APPLICATION NO.	FILING DATE	FIRST NAMED INVENTOR	ATTORNEY DOCKET NO.	CONFIRMATION NO.
10/540,138	06/21/2005	Georg Riescher	4100-357PUS	8881
27799 75	590 06/14/2006		EXAMINER	
COHEN, PONTANI, LIEBERMAN & PAVANE			FERGUSON, MARISSA L	
551 FIFTH AV SUITE 1210	ENUE		ART UNIT	PAPER NUMBER
NEW YORK,	NY 10176		2854	
DATE MAILED: (DATE MAILED: 06/14/200	6

DETAILED ACTION

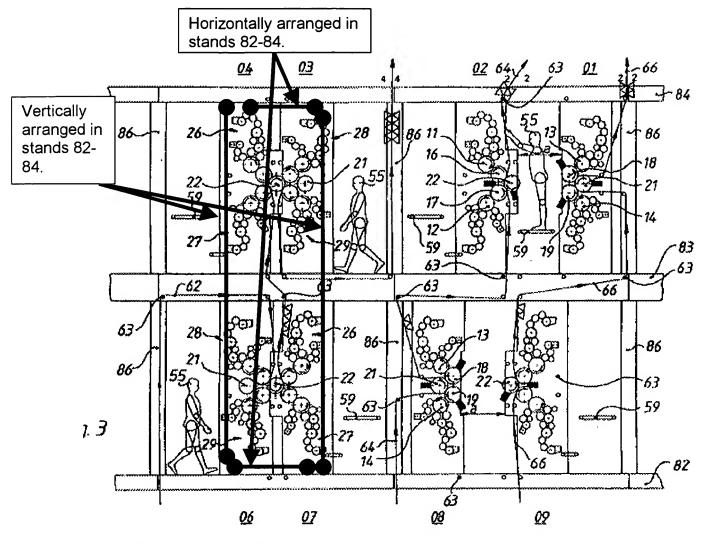
Regarding claim 11, Weschenfelder teaches a stand (82-84 and 86) having a drive side and an operating side, at least one crossmember (lateral frames 23 and 24 function as crossmembers) arranged at each of the sides of the stand and printing cylinders mountted in the crossmembers and forming a structural unit with the crossmembers such that the structural unit comprising the printing cylinders mounted on the crossmembers is removably received in the stand (Figures 3 and 4).

Regarding claim 14, Weschenfelder teaches wherein a crossmember is aligned one of horizontally and vertically in the stand (refer to figure on page 4 of office action).
